**CALIFORNIA ENERGY COMMISSION**

**SUBJECT: WALNUT ENERGY CENTER PROJECT (02-AFC-4C)  
NOTICE OF RECEIPT AND PUBLIC REVIEW OF STAFF ANALYSIS:  
ADDITIONAL WELLS TO SUPPLY BRIDGE AND BACKUP WATER**

**Walnut Energy Center (02-AFC-4C)**  
**STAFF ANALYSIS OF**  
**BRIDGE AND BACKUP WATER SUPPLY**

**July 8, 2005**

Map of Potential Well Locations and Pipeline Corridor

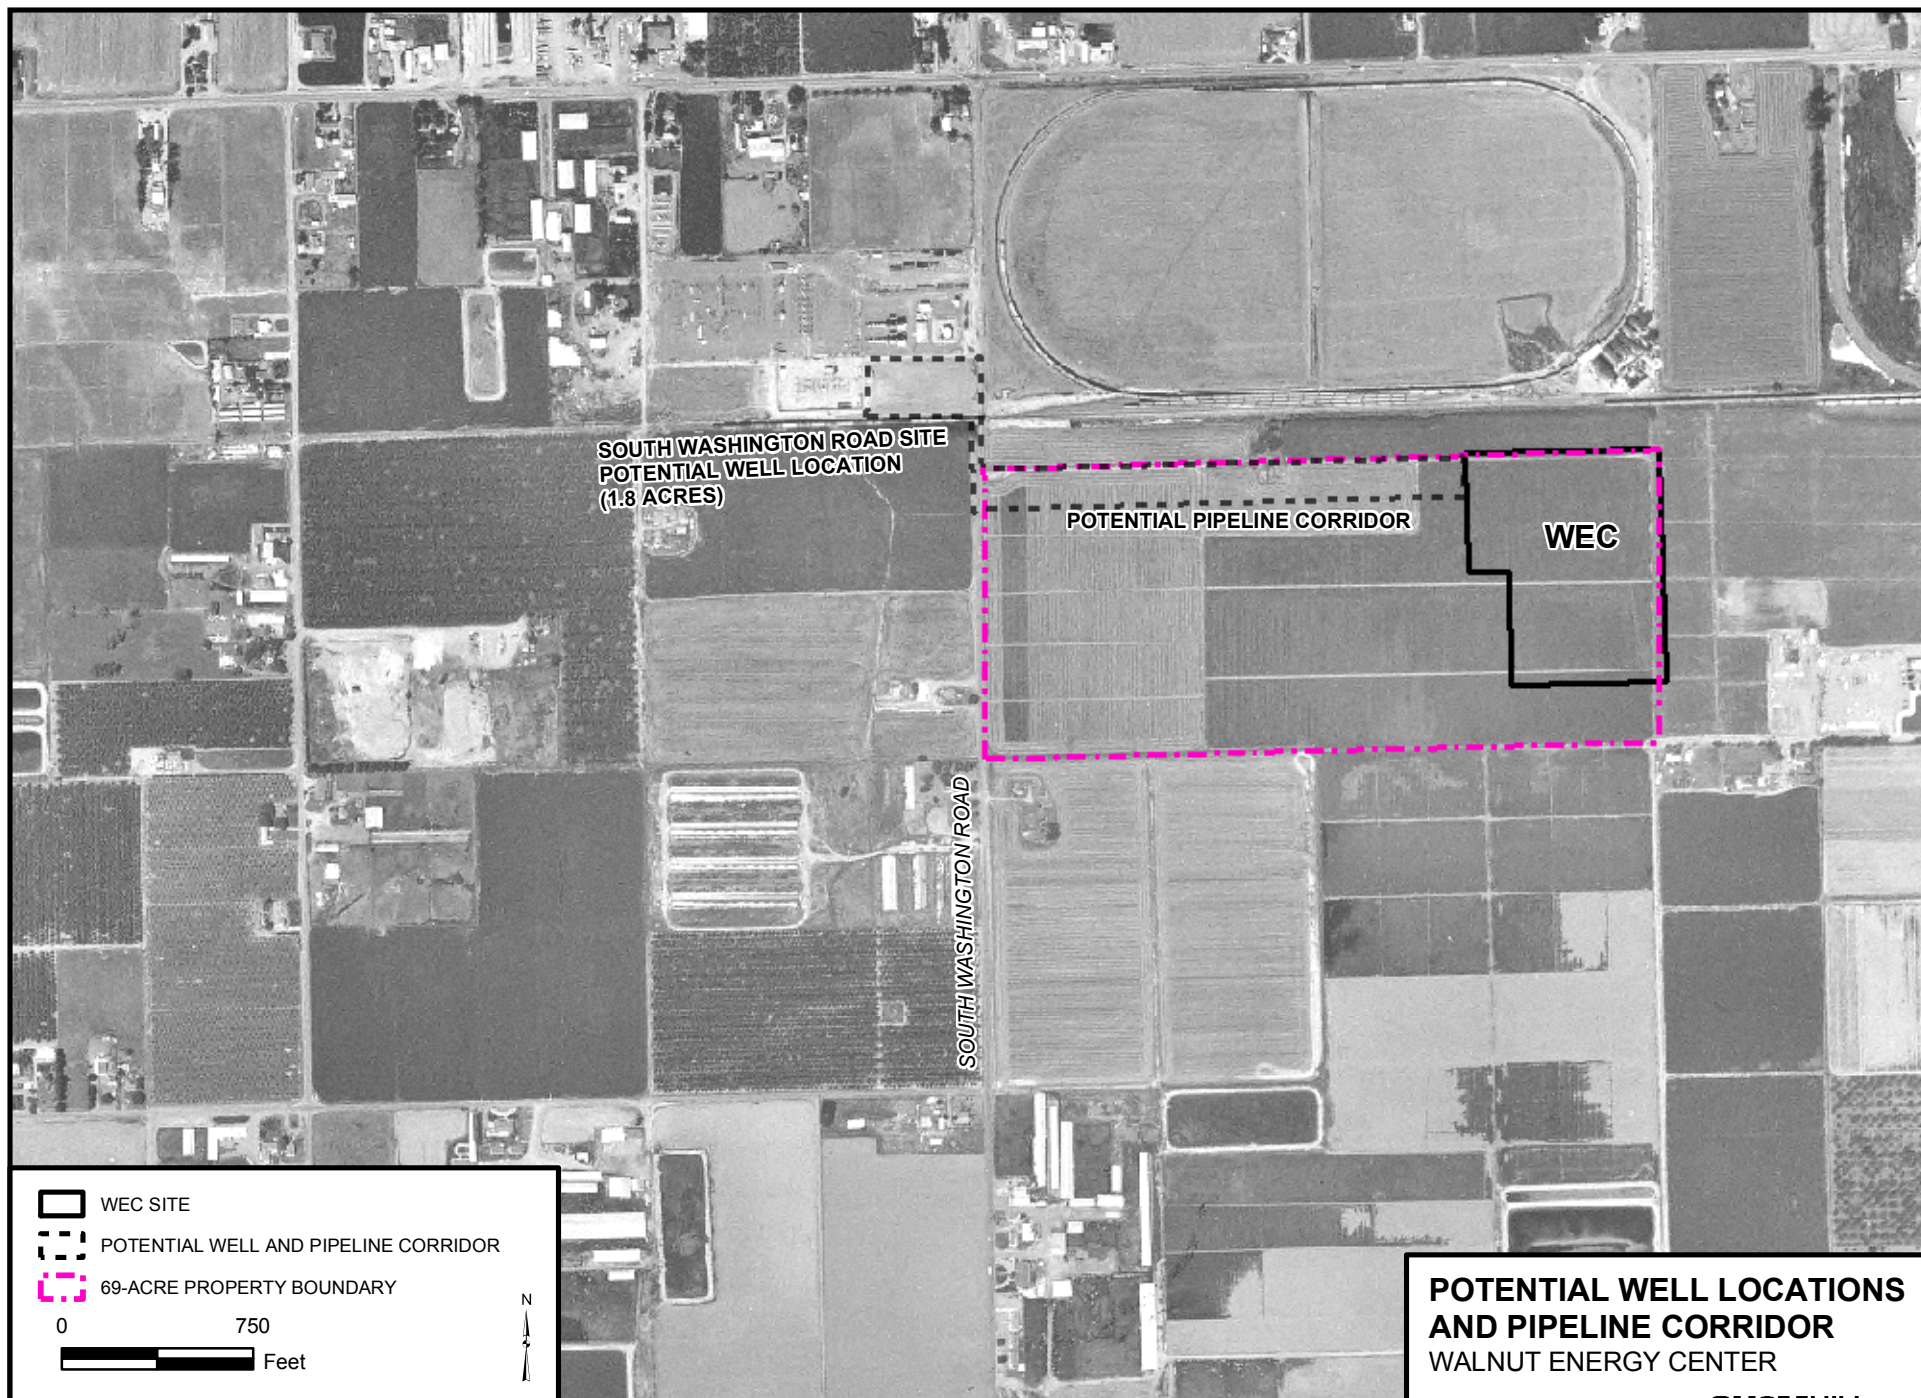
Therefore, WECA requests removal of the requirement that only two 100 percent capacity wells be developed, and instead be allowed to develop the number of wells needed, while not exceeding two million gallons per day (mgd) or 1800 acre feet per year (afy) as currently required. WECA also requests to develop wells on the 69-acre parcel on which the WEC project is located, rather than being limited to the 18-acre WEC project site.

WECA also requests that the option be preserved of locating two wells on the South Washington Road site. This is the 1.8-acre location of Turlock Irrigation District's South Washington Road equipment storage area, located immediately adjacent to its Walnut Peaker Plant and substation. A map showing the 1.8 acre South Washington Road site, the 18-acre project site, the 69-acre parcel, and the potential water pipe corridor if the wells are drilled on the South Washington Road site, is a part of this document.

The revised Soils & Water-5 condition (CEC 2005) also specified that the location of the wells would be restricted to the 18-acre WEC project site, which is located on a 69-acre parcel owned by the project. However, the operation of multiple production wells necessitates a larger well field to avoid drawdown interference between the wells. Therefore, WECA requests in this amendment to expand the original area designated well construction from the 18-acre project site to the 69-acre parcel.

During the bridge period, water used for cooling and steam cycle make-up shall consist of poor quality groundwater from the upper aquifer supplied from ~~either~~ **either one of two or more** groundwater wells located on ~~either the~~ **69-acre parcel that includes the 18-acre** WEC project site **(the “69-acre Acre Parcel”)** or the **two 100 percent wells located on the** TID equipment storage area on South Washington Road (the “South Washington” site). ~~Only one of the two groundwater wells may be operated at any time (with the other well serving as a 100 percent redundant backup).~~ **Total combined Ggroundwater** production from **all of the wells on both the 69 Acre Parcel and the South Washington site** shall not exceed two million gallons per day or 1,800 afy.
